RE: DRAINAGE PLAN FOR BUILDING "C" OF CHERRY HILLS SHOPPING CENTER
(D19-D23) ENGINEER'S STAMP DATED 6/3/94.

GRADING & DRAINAGE PLAN

FOR
BUILDING C OF THE CHERRY HILLS SHOPPING CENTER
WYOMING BLVD. AND SAN ANTONIO DR.
ALBUQUERQUE NEW MEXICO
JUNE, 1994

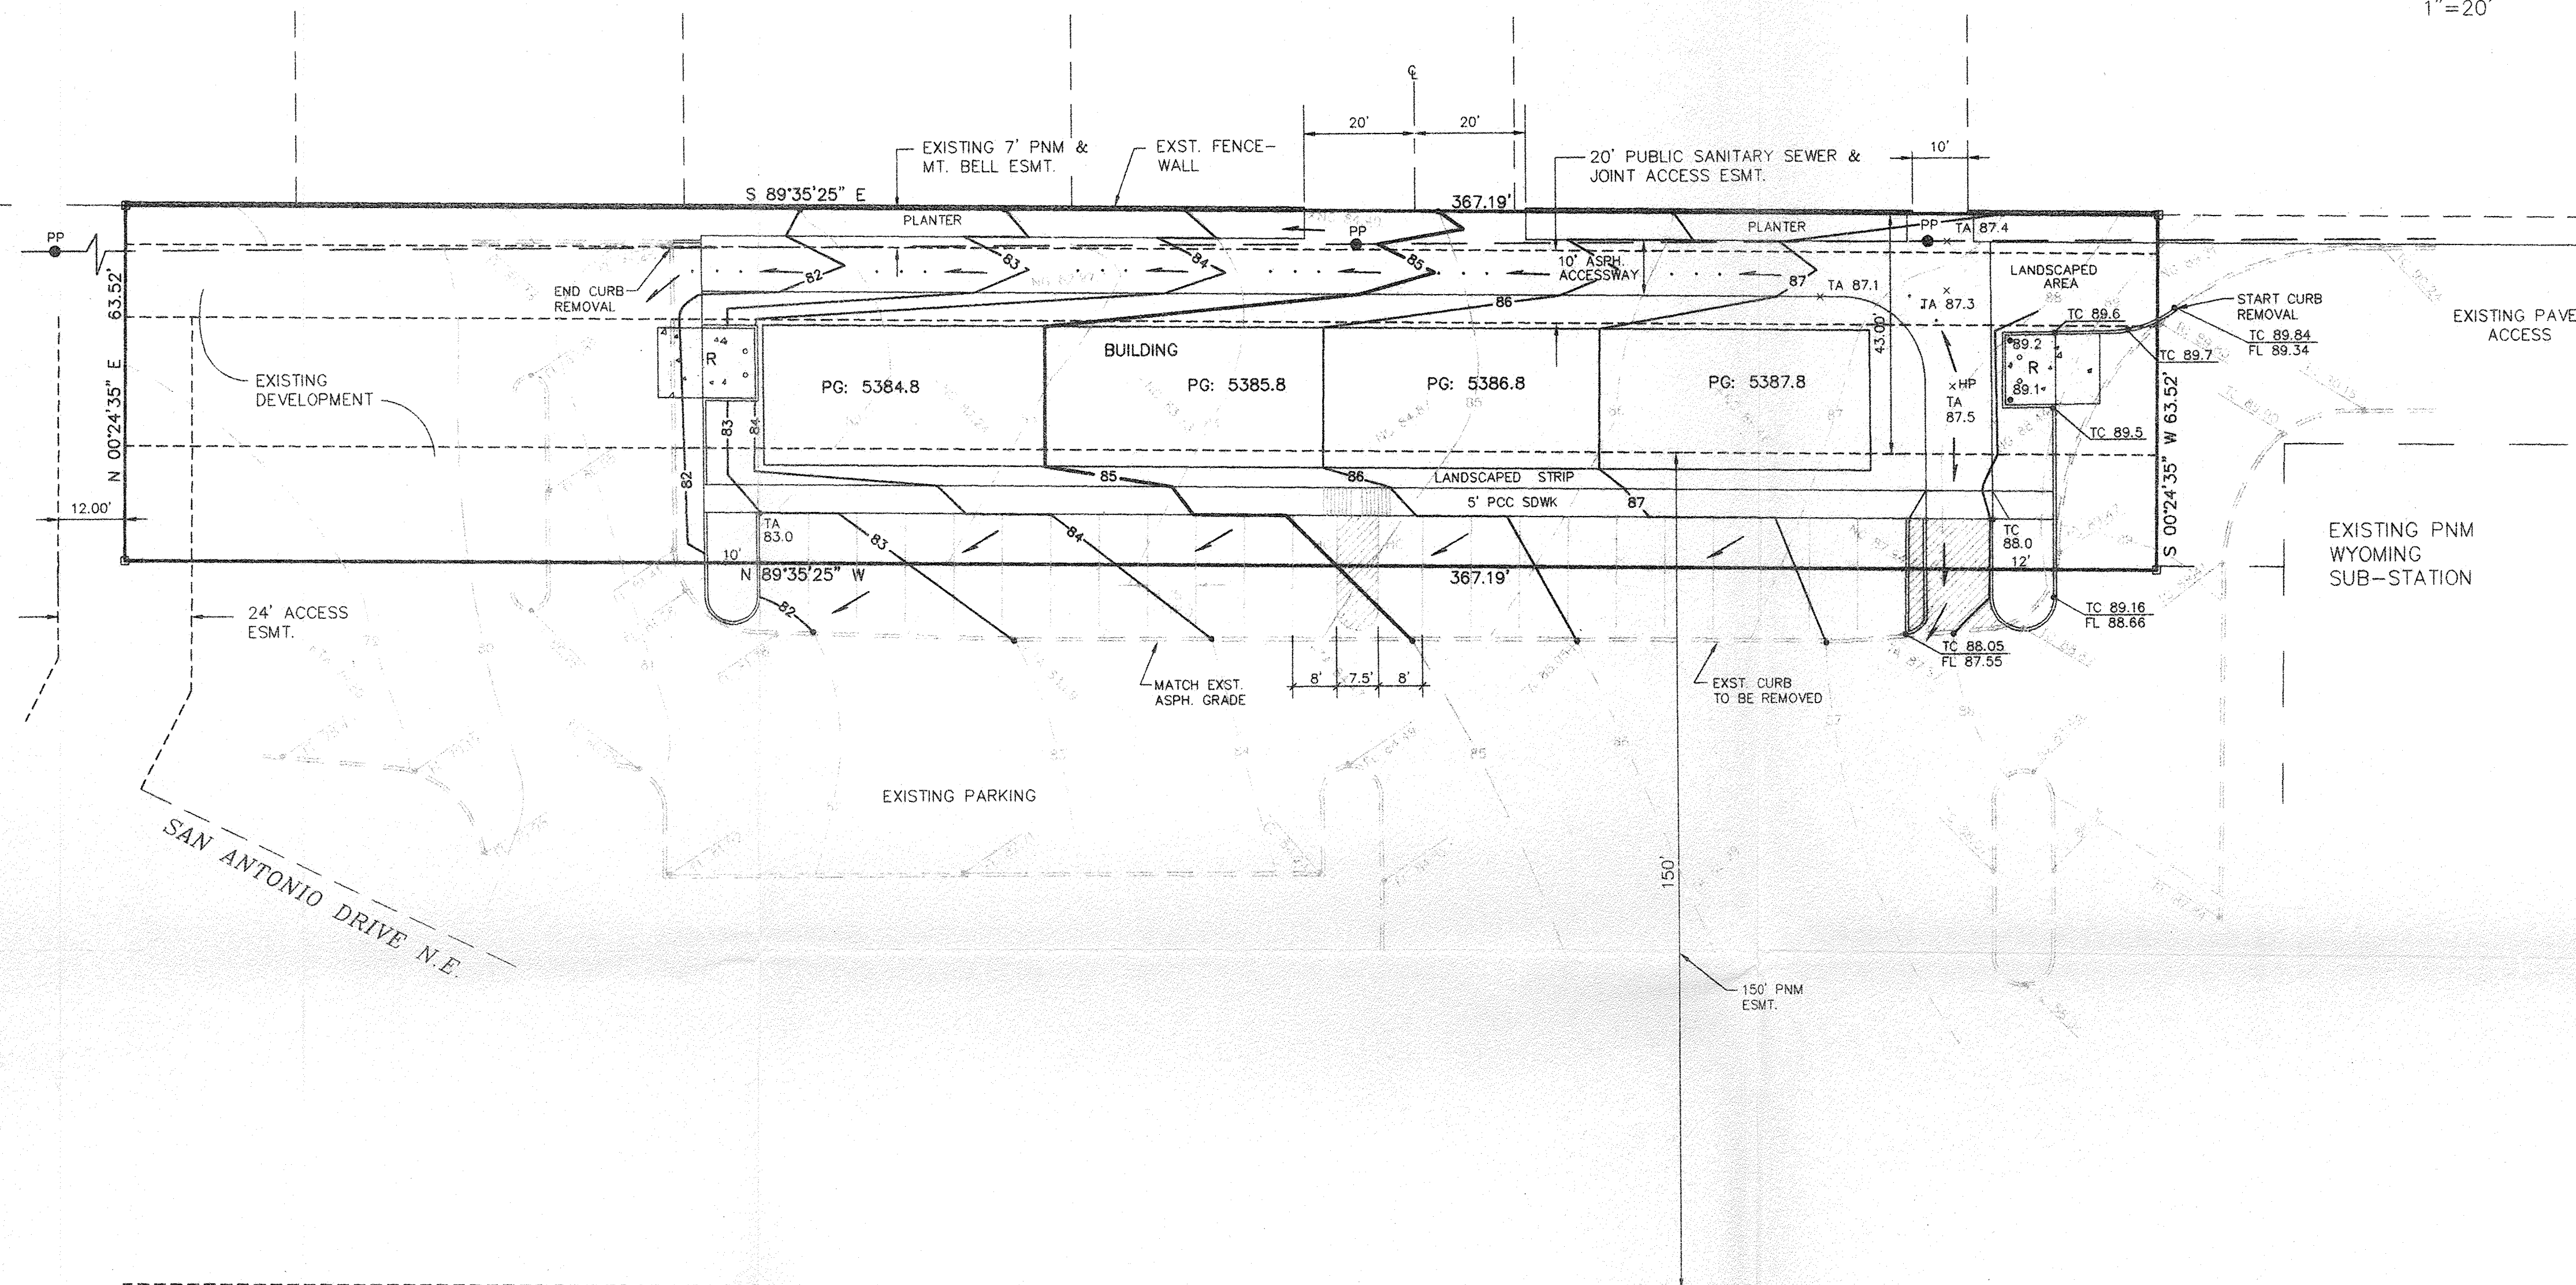
Based on the information provided on your June 3, 1994 submittal, the above referenced site is approved for Building Permit.

Please attach a copy of this approved plan to the construction sets prior to sign-off by Hydrology.
